OUR REF: 19313_WW REV E COVER LETTER.DOCX YOUR REF: DA 10.2021.114.1

9 December 2021

Re: 'Request for Further Information' – DA 10.2021.114.1 – Light Industrial development at Lot 10 DP 790360, 467 Federal Drive, Federal.

Figure 1. Greatest distance between a trade waste tank and pump out truck access point.

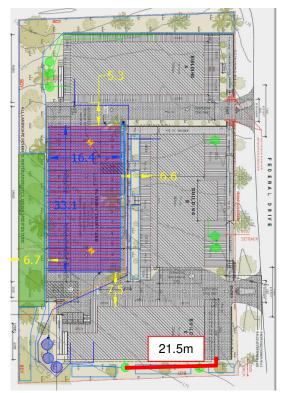
3. Please amend the OSMS report to include any wastewater load from visitors/patrons as only tenants are discussed, and details on access for emptying the liquid trade waste tanks depicted within the report. Visitors and patrons to the light industrial sheds are not permitted to utilise the toilet amenities within the proposed development. Toilet access is to be via lock and key with tenants instructed not to provide toilet access to any visitors

Regarding access to liquid trade waste tank, Figure 1 highlights the greatest distance between the most distant trade waste tank to a pump out truck access point. It can be seen that the greatest distance a pump out truck will have to reach is 21.5m (including 2.0m depth of tank). This distance is acceptable as Summerland Environmental have confirmed that their pump out trucks have either 30m or 40m length hoses.

Three tanks within Figure 1 are shown to be installed under decking to the east of building B (middle building). It is proposed that the decking will be constructed with removable hatches to allow access to the tanks. The deck will be required to be engineered to allow the installation of the under-deck tanks.

DA. What is shown in Figure 1 can be considered a 'worst case' scenario given the number and size of the tanks shown. The tanks depicted in Figure 1 are 2000L volume tanks, which may be reduced in number, size and location within the Section 68 application.

Figure 2. Setbacks between OSMS tanks and neighbouring dwellings.

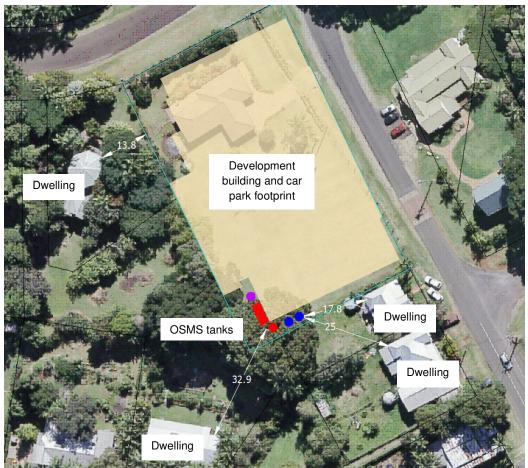
- 4. A kitchenette is mentioned in OSMS report but is not shown on building plans. Please confirm if a kitchenette is proposed in the development, and if so, provide amended plans demonstrating its location. Revised floor plans showing kitchenettes are attached to this letter.
- 5. Location of OSMS treatment tanks and some trade waste tanks do not provide ease of access. The location of the OSMS treatment tanks with an aerator operating 18 hours a day is close to three neighbours. Access to OSMS treatment tanks is not a constraining issue. The distance between the most distant OSMS tank and car park is 25m (including 2m tank depth) which is accessible by a standard pump out truck (See point 3 response).

The location of the shown OSMS tanks is positioned to receive all wastewater generated on the site under gravity. Positioning the OSMS tanks in the NW corner of the property will mean two OSMS tanks with internal pumps will still be required in the location shown as they will be needed to transfer both greywater & blackwater to the OSMS treatment tanks as gravity flow will not be achieved.

Figure 2 shows that the location chosen for the OSMS tanks creates a minimum 17.8m setback to the closest neighbouring dwelling. It also shows that if the OSMS tanks were positioned in the NW area of the property they will be a similar distance to a neighbouring dwelling (most likely \approx 17m), as indicated by the dimension given on the plan.

17.8m is considered an acceptable setback to an OSMS. Domestic OSMS's that utilise aerators and pumps are commonly placed within 17.8m of neighbouring dwellings in village settings. The OSMS nominated within the Section 68 application can be programmed for the aeration and pumping sequences to occur during daylight hours and will be made to be compliant with the NSW EPA *Noise Policy for Industry* (2017). This will be possible as wastewater generation will be during daylight hours matching the developments operational hours.
